CHANGES AS SUBMITTED IN S4.55 -
UNDER REVIEW - MOD/2024/0225

1728 Fortis South Steyne

34-35 South Steyne Manly NSW

TITLE
GFA & NLA Diagrams
GFA Diagrams Sheet 1

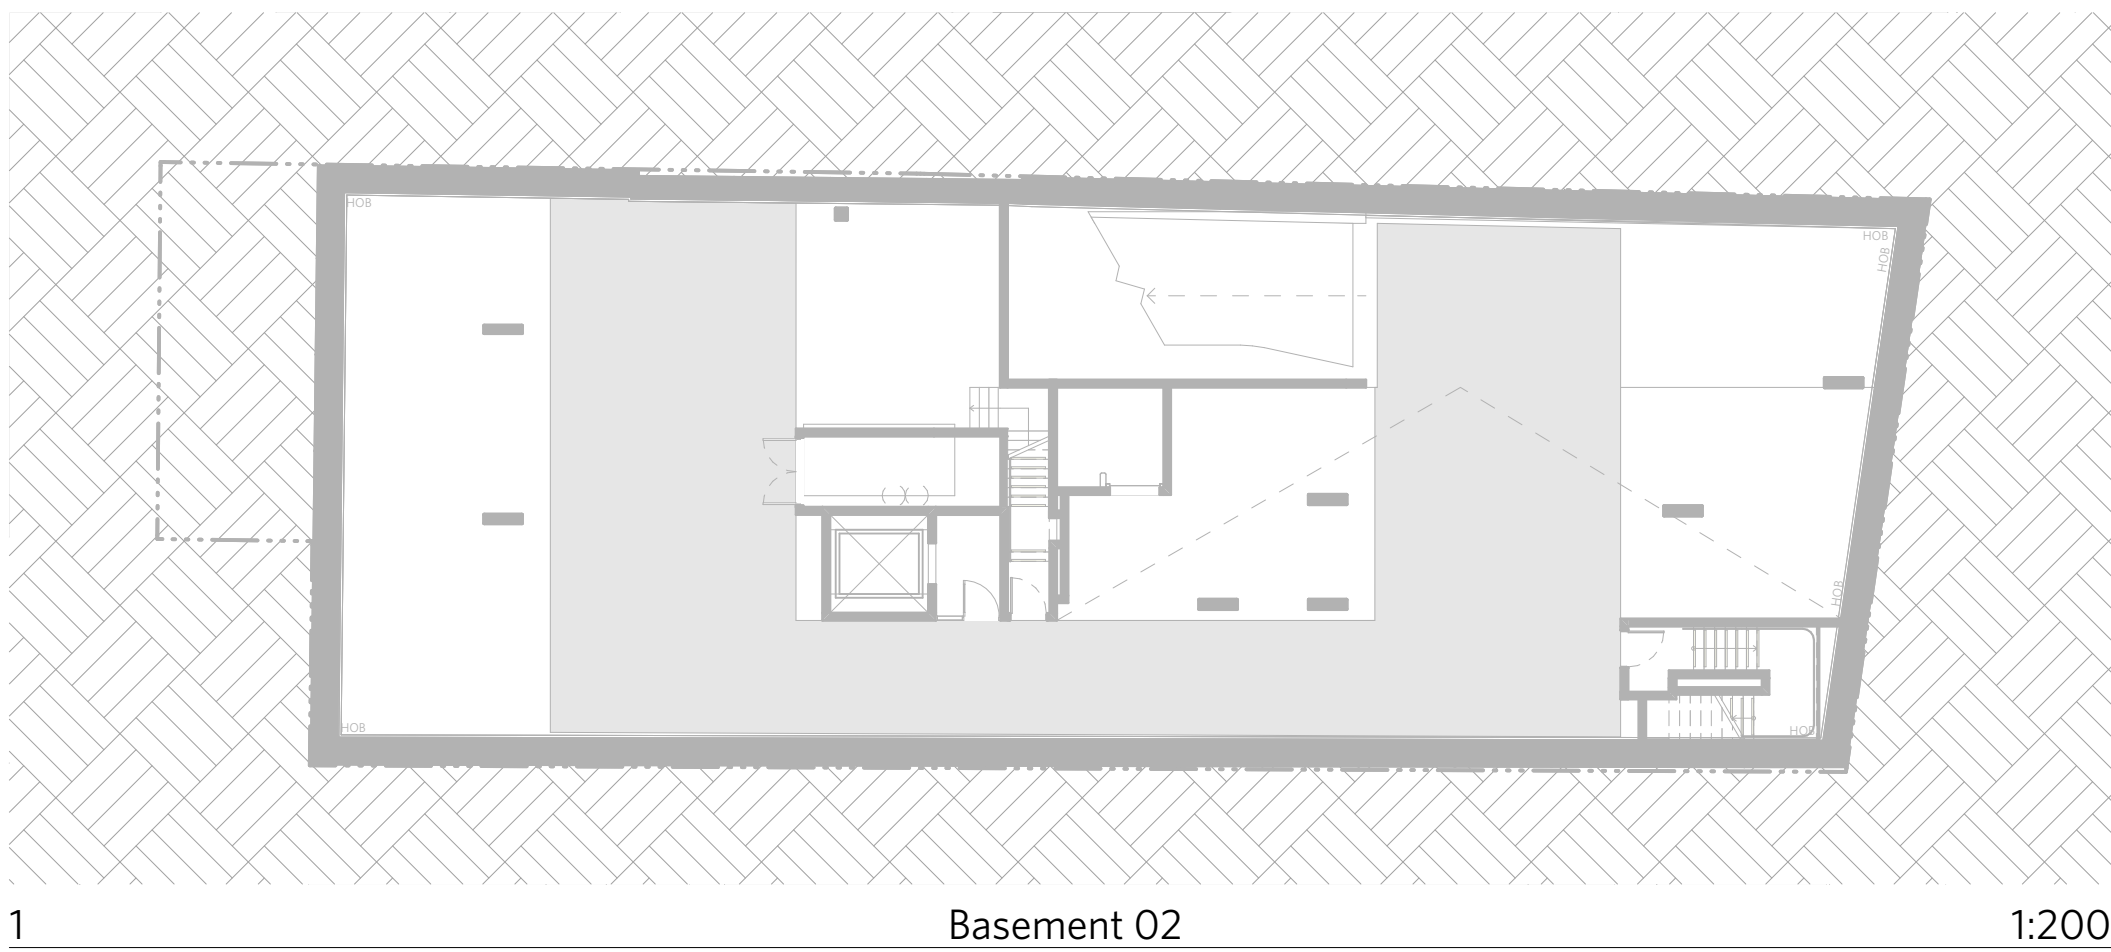
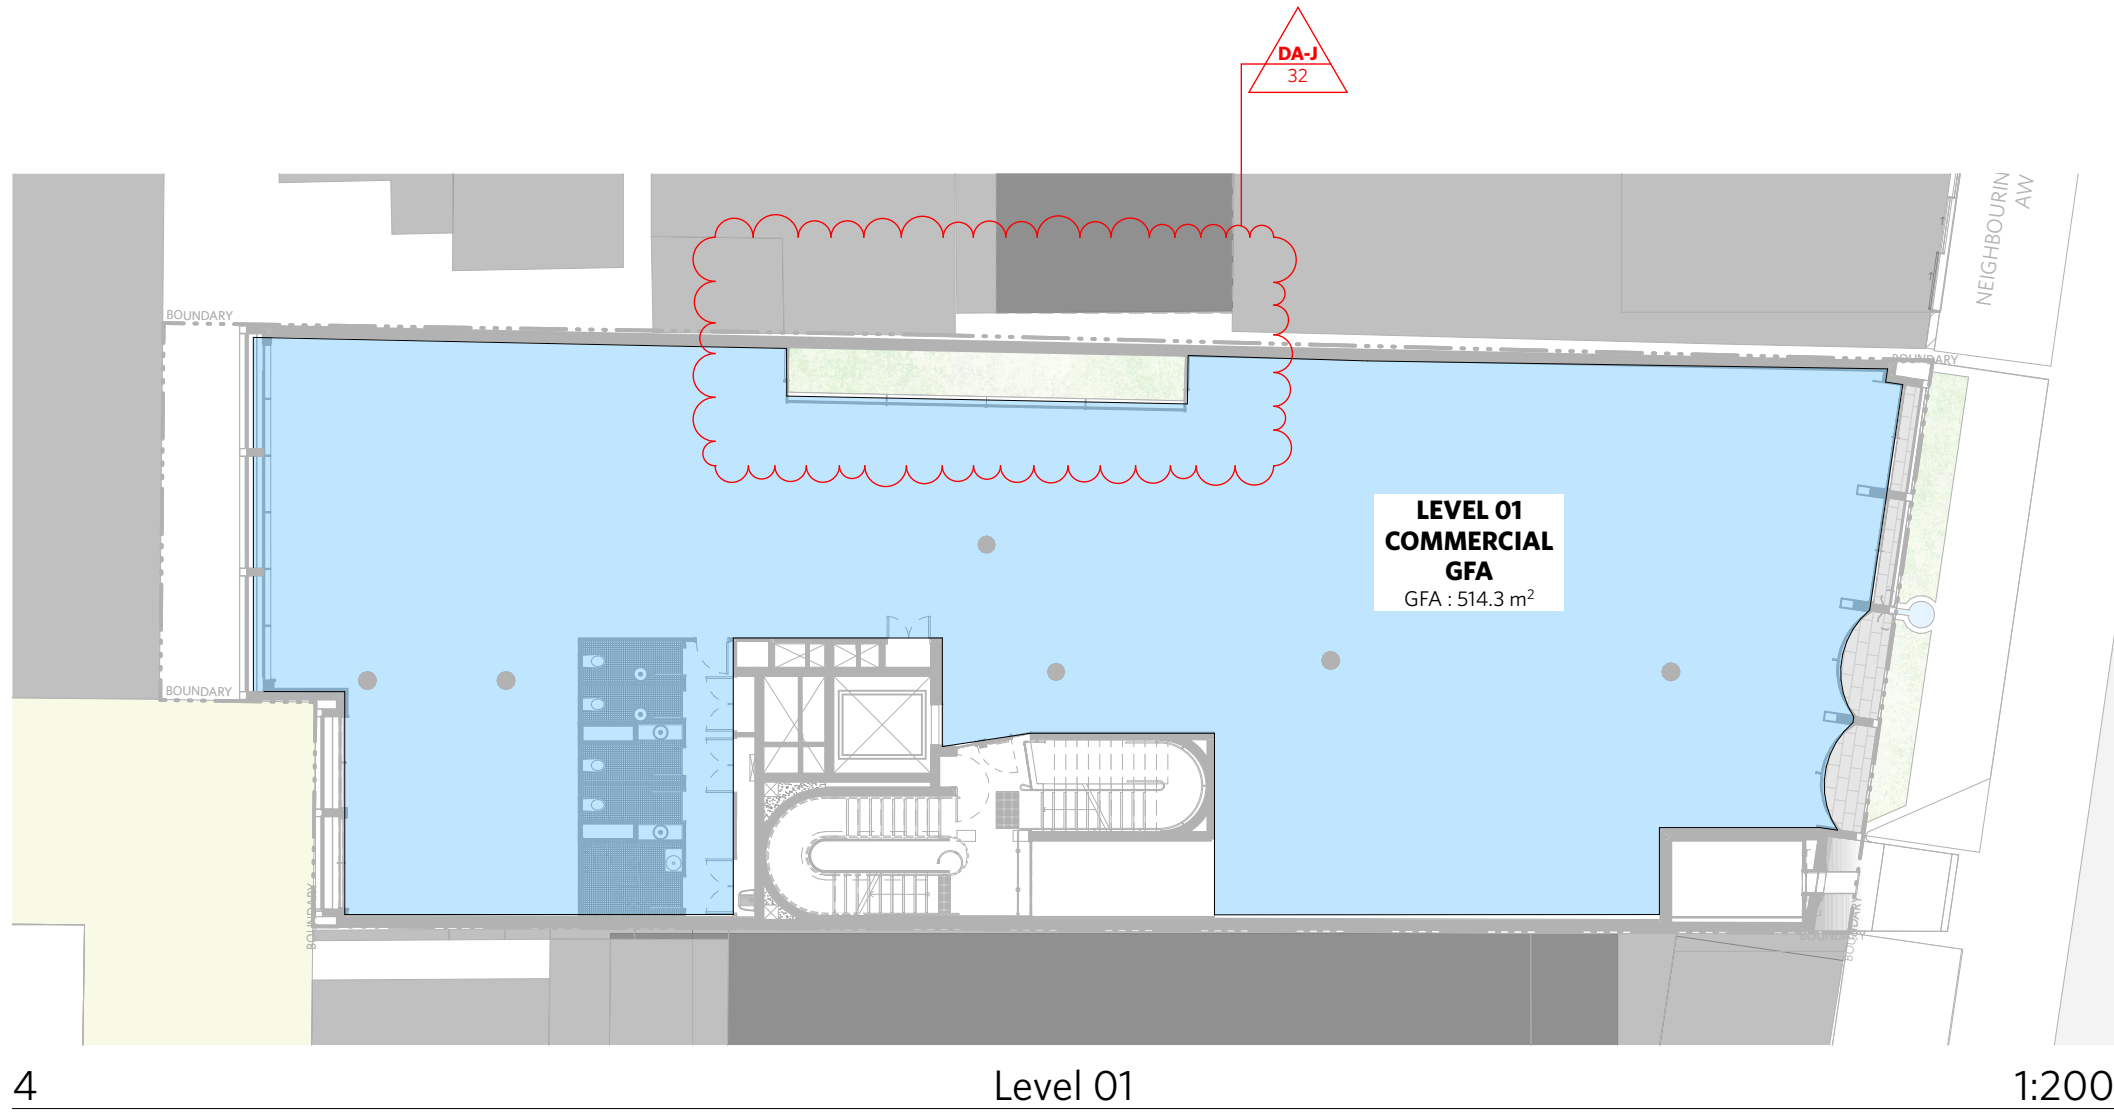
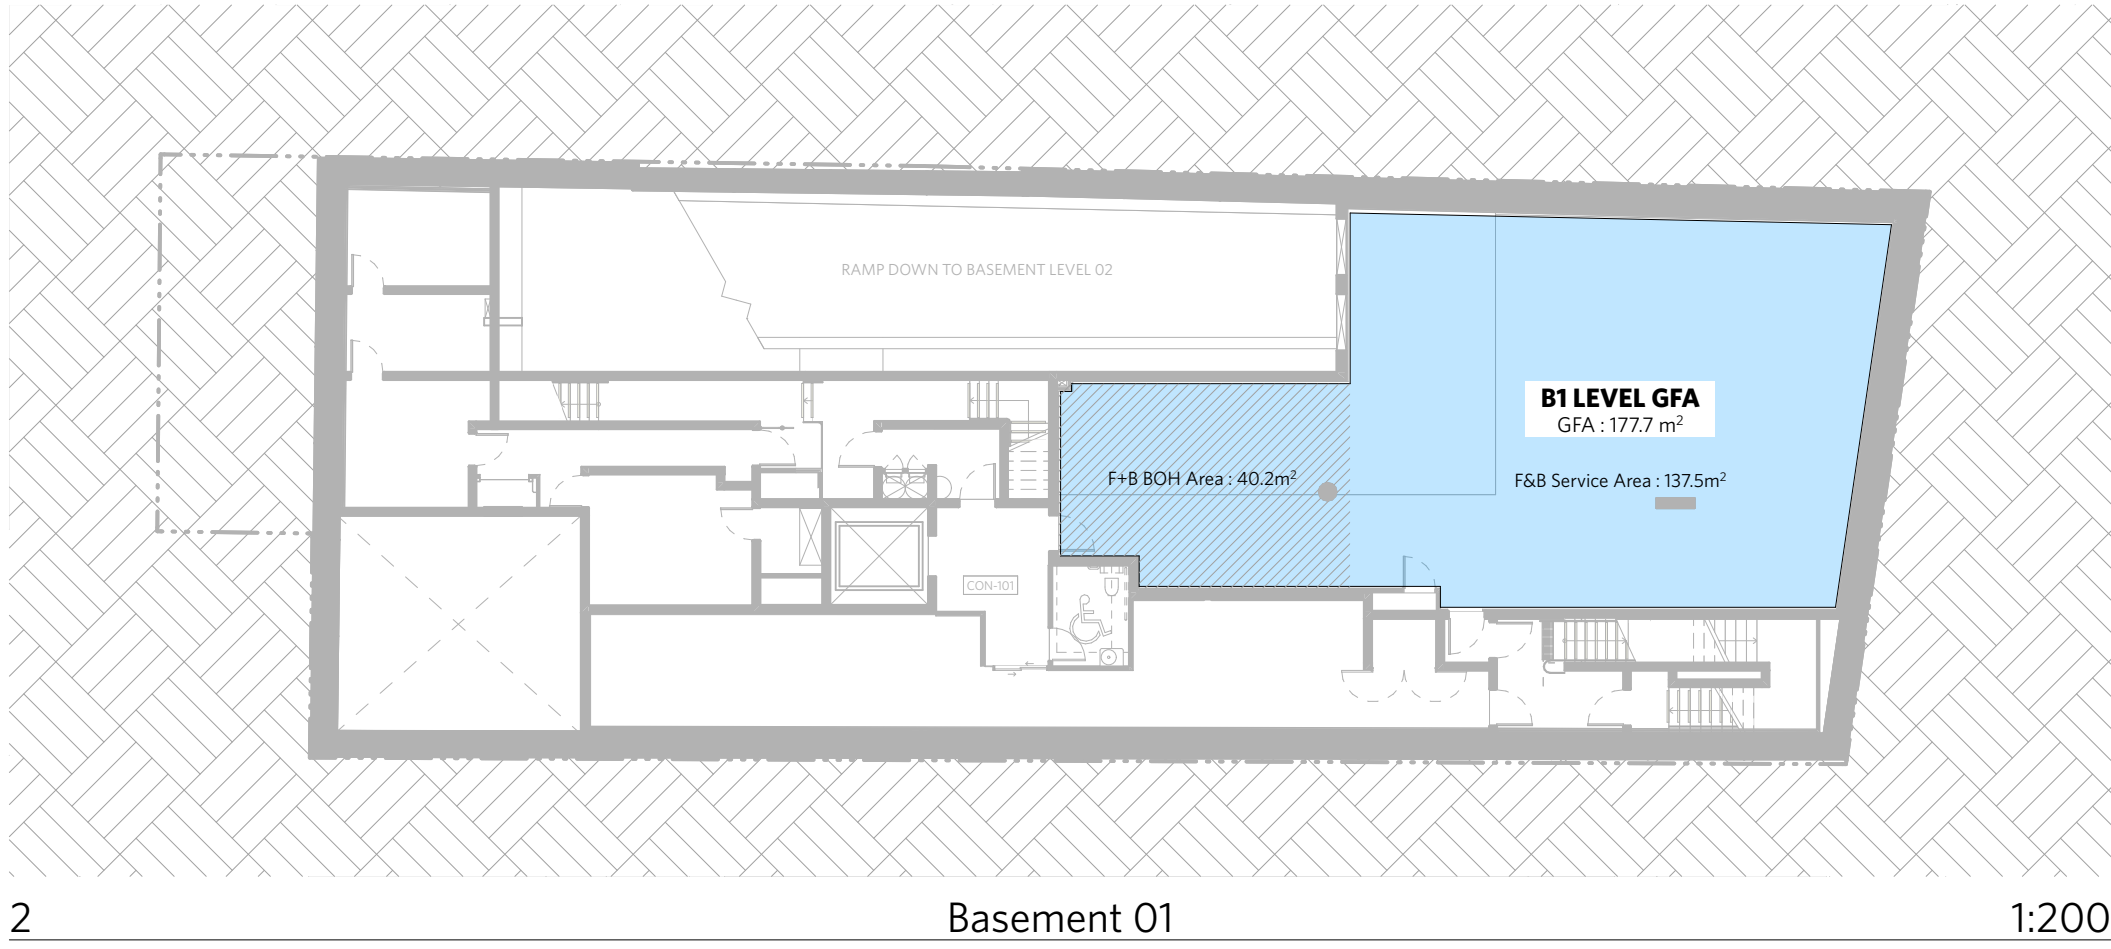
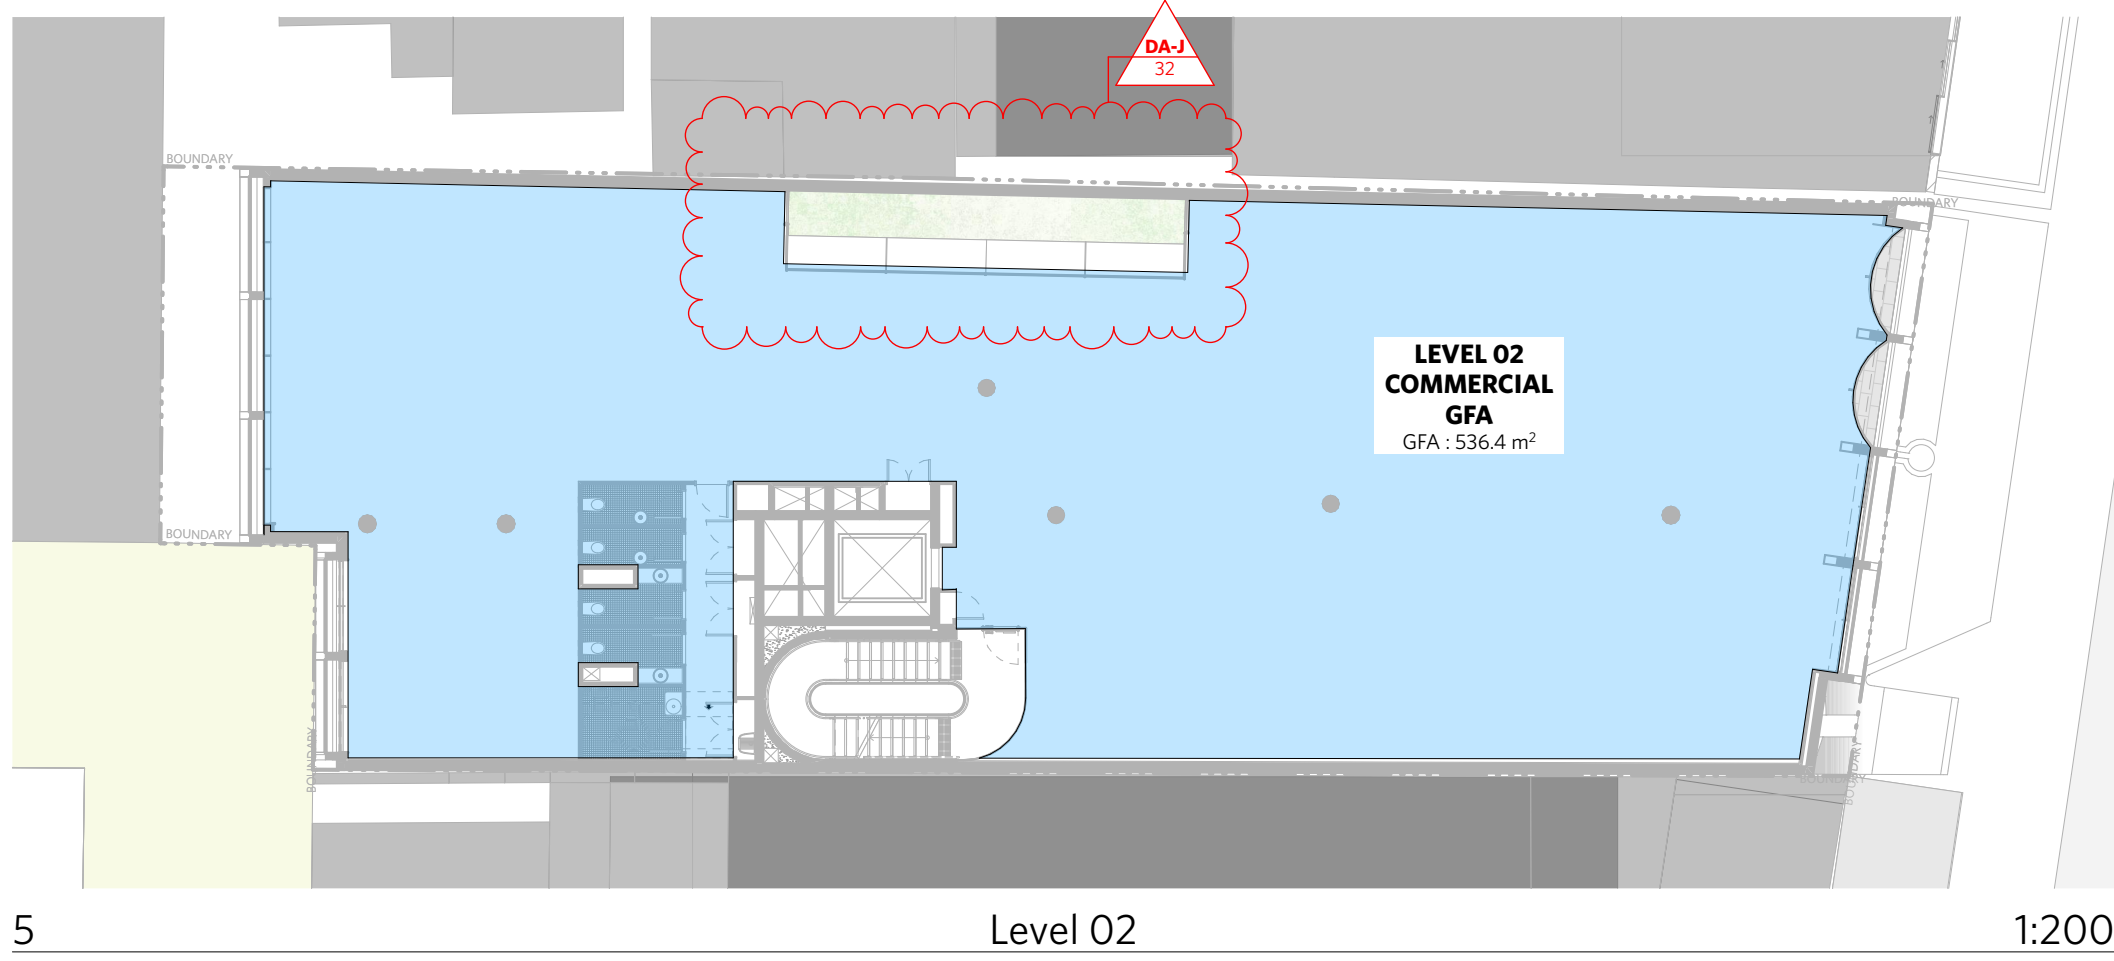
CHANGE SUMMARY		
REV	CHANGE	DESCRIPTION
DA-J	27	Increase in Floor Space to the west
	32	GFA Adjustment due to changes
